1. Type of Well			8. Well Name and No.	/	
Oil Well	Gas Well	Other	South Lus	k 33 Federal #1	
2. Name of Operator	Apache Corporation	on /		9. API Well No.	
				25-36312	
3a. Address		. (include area code)	10. Field and Pool, or Explo		
303 Veterans Airpark Lane, I		2-818-1106		rrow East Gas	
4 Location of (Footage, Sec., T., R,	or Survey Description)		11. County or Parish, State		
1545' FNL & 1980' FWL, Sec 33, T19S, R32E				Lea	
		eec.	ICE DEPORT OF OTHER DA		
	OPRIATE BOX(ES) TO INDICAT			ATA	
TYPE OF SUBMISSION		TYPE	OF ACTION		
[7] Martine of Intent	Acidize	Deepen	Production (Start/Resume)	Water Shut-off	
✓ Notice of Intent	Alter Casing	Fracture Treat	Reclamation	Well Integrity	
Subsequent Report	Casing Repair	New Construction	Recomplete	Пол	
Subsequent Report			F	L_J Other	
Final Abandonment Notice	Change Plans	Plug and Abandon	Temporarily Abandon		
I mai / tourdommont i tource	Convert to Injection	Plug Back	☐ Water Disposal

LEASE NAME
 South Lusk 33 Federal

API #
 30-025-36312

LEASE NAME	South Lusk 33 Federal	
WELL#	#1	
API#	30-025-36312	
COUNTY	Lea

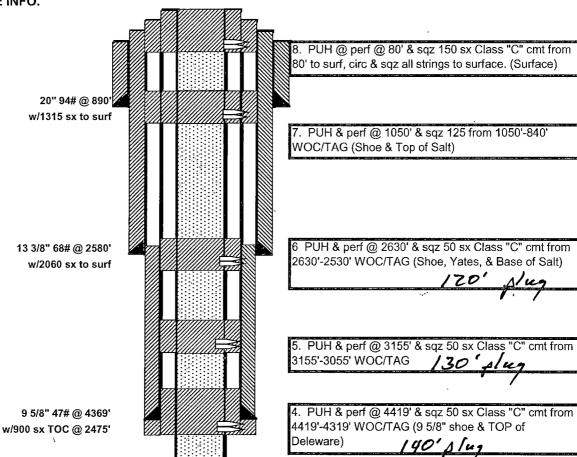
Add Aleg 9806-9606 CDVT, 3 Rd B/S woc/ Tay)

Plug = 100' plus 1020 per 1000'
